Project	IEEE 802.16 Broadband Wireless Access Working Group < http://ieee802.org/16 >	
Title	Editorial suggestions for the 16h Working Document facilitating License-Exempt amendment to 802.16-2004	
Date Submitted	2005-11-08	
Source(s)	Paul Piggin Cygnus Communications 2075 Las Palmas Drive Carlsbad CA 92009	Voice: 760 448 1984 Fax: 760 448 1989 ppiggin [at] cygnuscom.com
Re:	Call for Contributions, IEEE 802.16h Task Group on License-Exempt Coexistence, IEEE 802.16h-05/023	
Abstract	This document puts forward some editorial suggestion to be applied to the 16h Working Document that will provide a basis for the addition of License-Exempt operation within the base standard (802.16-2004).	
Purpose		
Notice	This document has been prepared to assist IEEE 802.16. It is offered as a basis for discussion and is not binding on the contributing individual(s) or organization(s). The material in this document is subject to change in form and content after further study. The contributor(s) reserve(s) the right to add, amend or withdraw material contained herein.

Editorial suggestions for the 16h Working Document facilitating License-Exempt amendment to 802.16-2004

Figure 2 Example of the use of DFS and ACS in 802.16

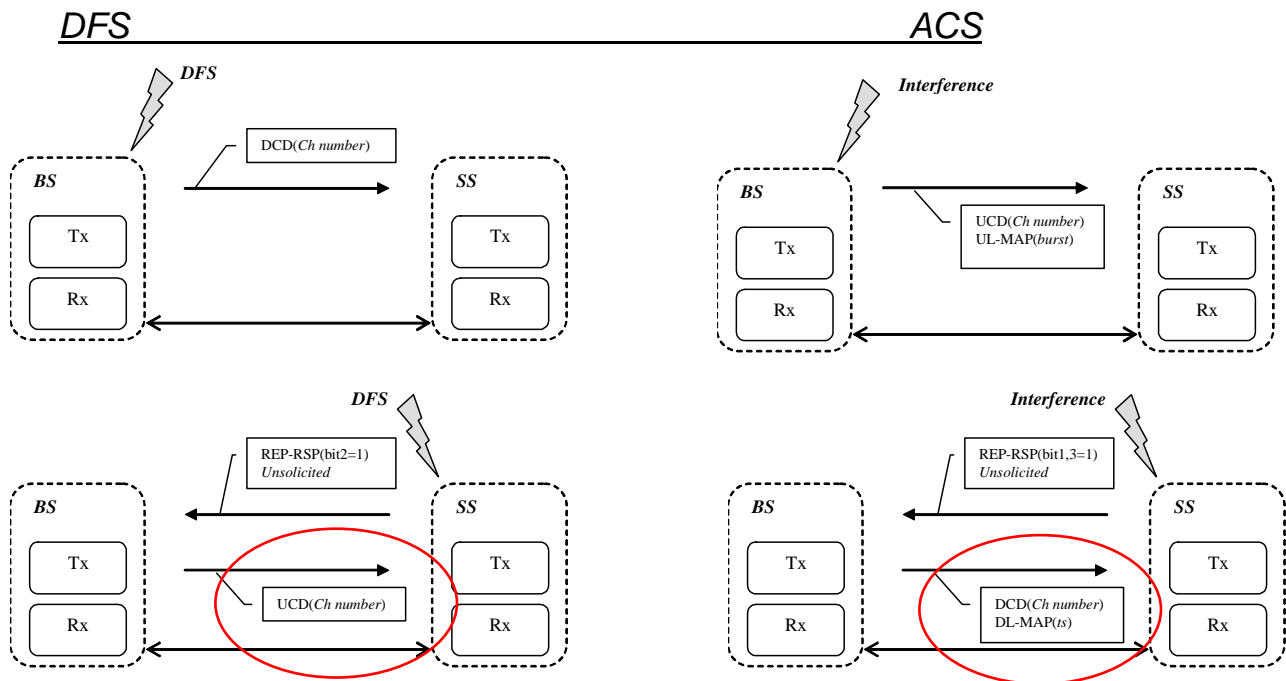
At present there is a single byte used to specify the *channel number* for LE operation (see Figure 2). This is used for specification of frequencies between 5-6GHz in section 8.5. This byte is referenced in TLVs and channel measurement IEs. The *channel number* granularity is 5MHz (this could need changing going forward - TBD). It is likely that this *channel number* will need extending to cover <11GHz references. The author feels that the most prudent way to proceed is to add a number *channel number* rather than extending the existing one.
